Item ID: D206-667-103

Item Name: Fwd High Crosstube 206L/L1/L3/L4

DRAWING NO. D206-667-143	TITLE CROSSTUBE ASS'Y (206L HIGH FWD)	REV. C	DART AEROSPACE LTD ENGINEERING ORDER		D.E.O. NO. D206-667-143-C-1	SHEET NO. SHEET 1 OF 1	SCALE NTS
DRAWN <i>q</i>	CHECKED <i>ASS</i>	MFG. APPR. <i>[Signature]</i>	APPROVED <i>MD</i>		DE APPR. <i>[Signature]</i>		
DATE 11.07.15	DATE 11.07.20	DATE 11.07.21	DATE 11/07/21		DATE 11.07.21

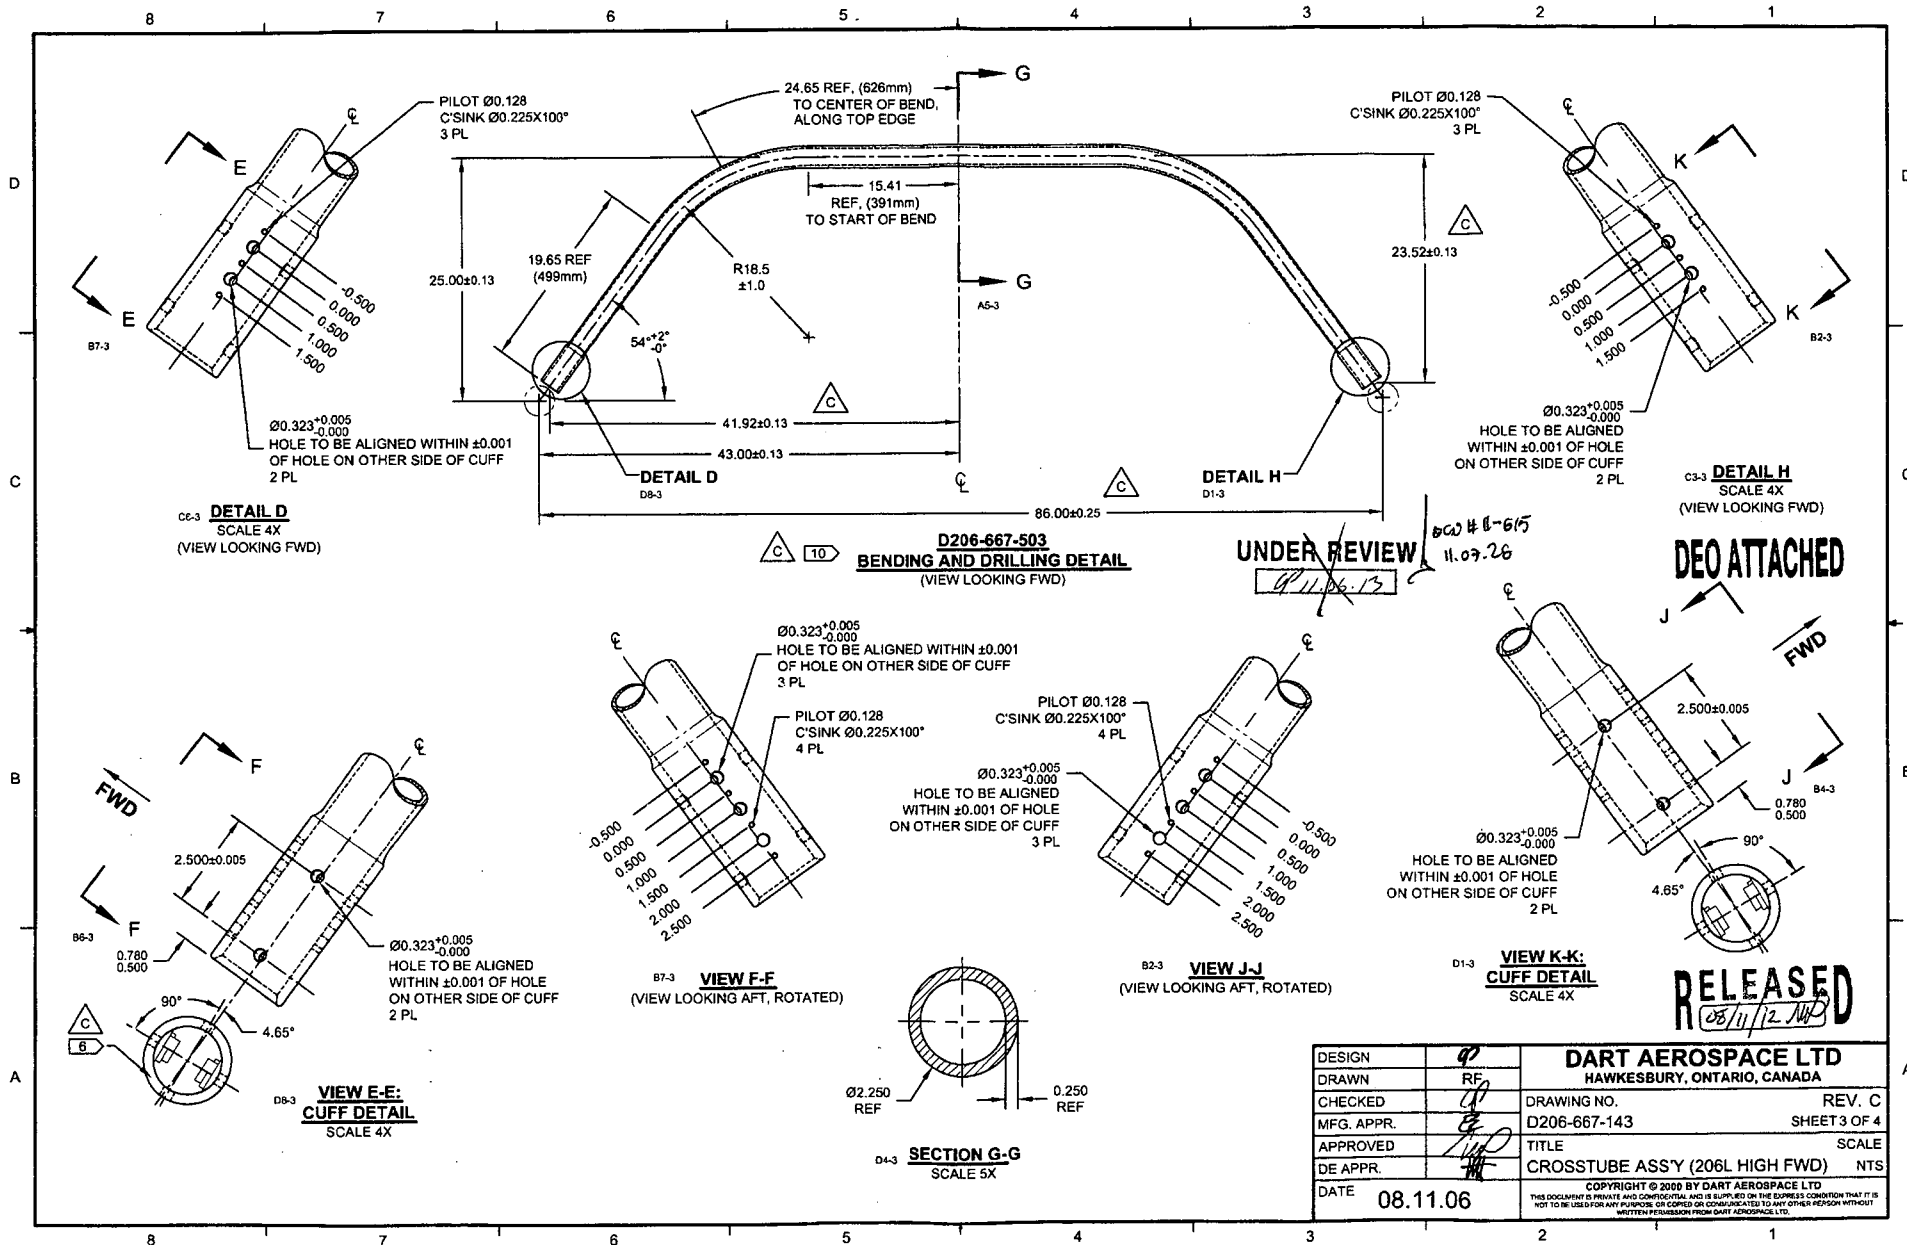
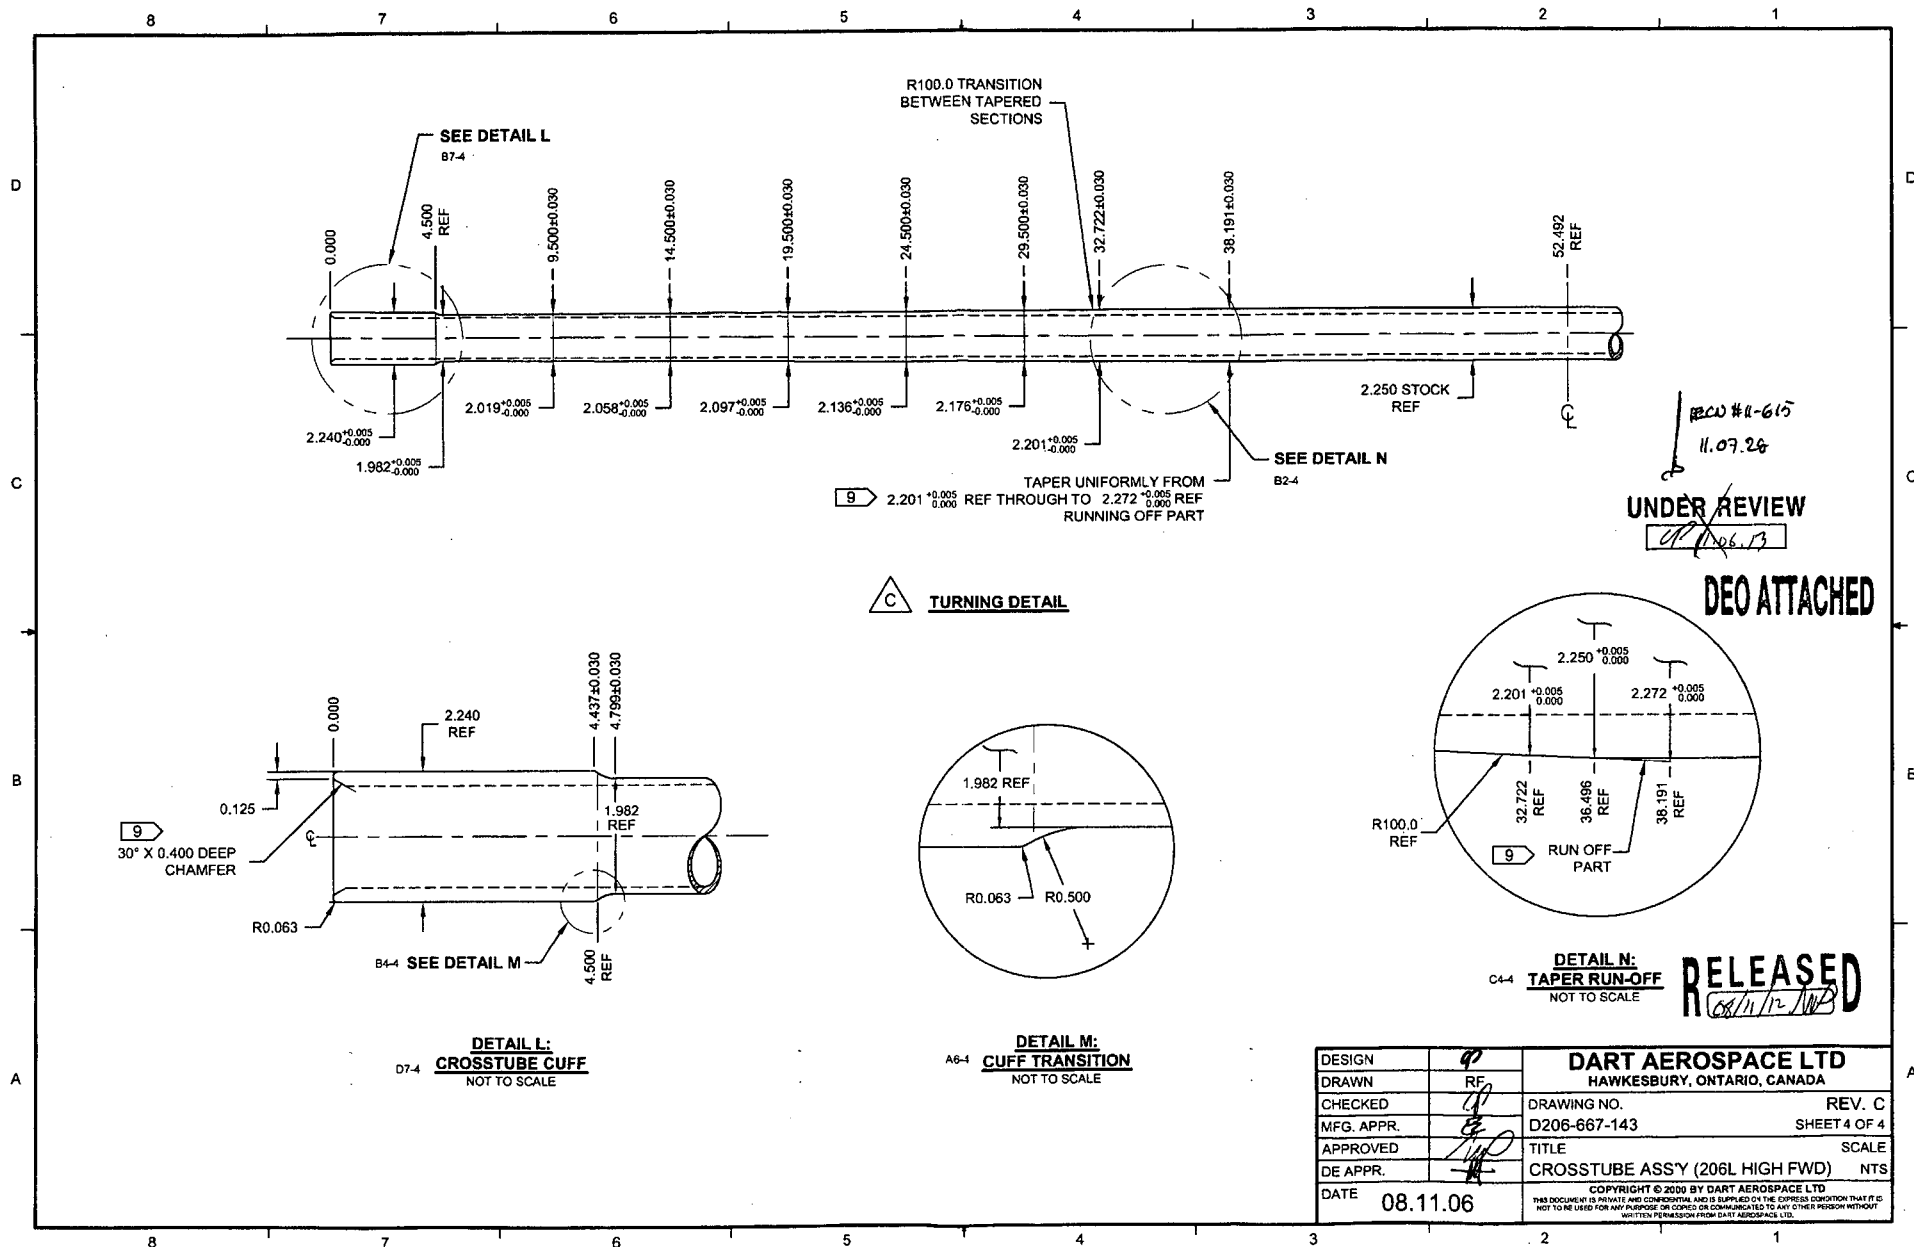
PURPOSE:

REPLACE MAGNOBOND WITH PROSEAL.

NOTE 12 & 15, SHEET 1 IS AMENDED AS FOLLOWS:

- 12) TO INSTALL D2891-1 SUPPORT: ABRABE MATING SURFACE OF SUPPORT AND CROSSTUBE WITH 180-GRIT SANDPAPER AND REMOVE RESIDUE WITH MEK (OR EQUIVALENT). APPLY A 0.04" TO 0.07" THICK LAYER OF PROSEAL 890 CLASS B-2 (OR AMS-S-8802 CLASS B-2) SEALANT TO MATING SURFACE OF SUPPORT.
- 15) TORQUE CLAMPS 80 TO 100 IN-LB. ENSURE AT LEAST 1.5 THREADS SHOWING IN SAFETY AND THAT NUT HAS NOT BOTTOMED-OUT AFTER TORQUING. **PRIOR TO PACKAGING, RE-CHECK TORQUE ON CLAMPS AFTER PROSEAL 890 SEALANT HAS CURED FOR 72 HOURS.**

DETAIL P
BONDING STRAP INSTALLATION 2 PL

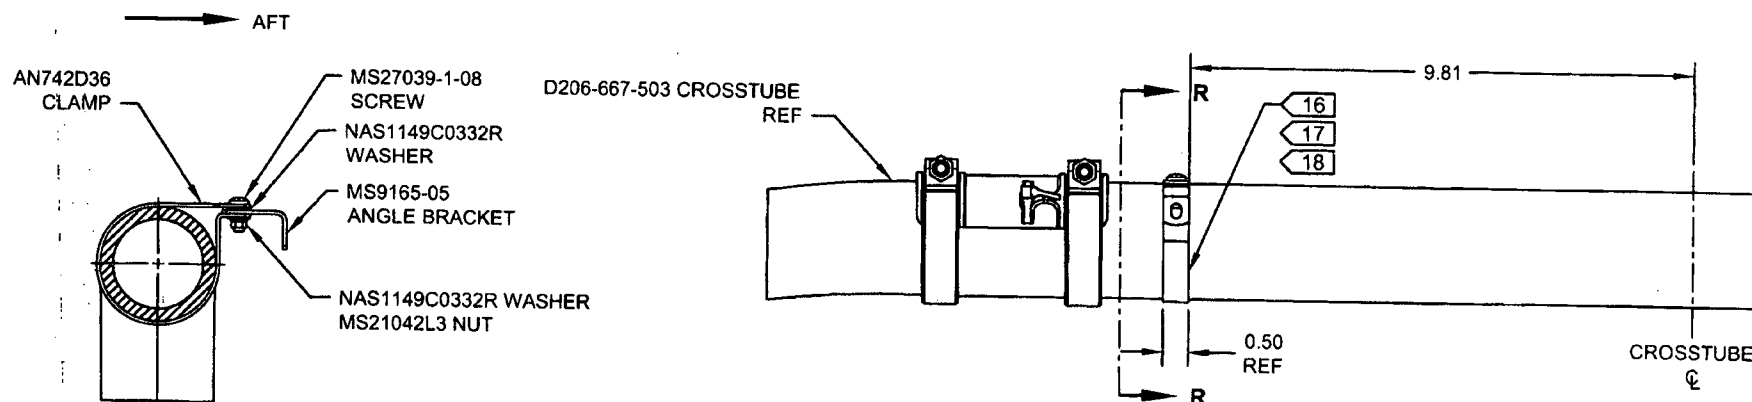
ADD ELECTRICAL GROUNDING STRAP

CHANGE:

PARTS LIST:

ADD
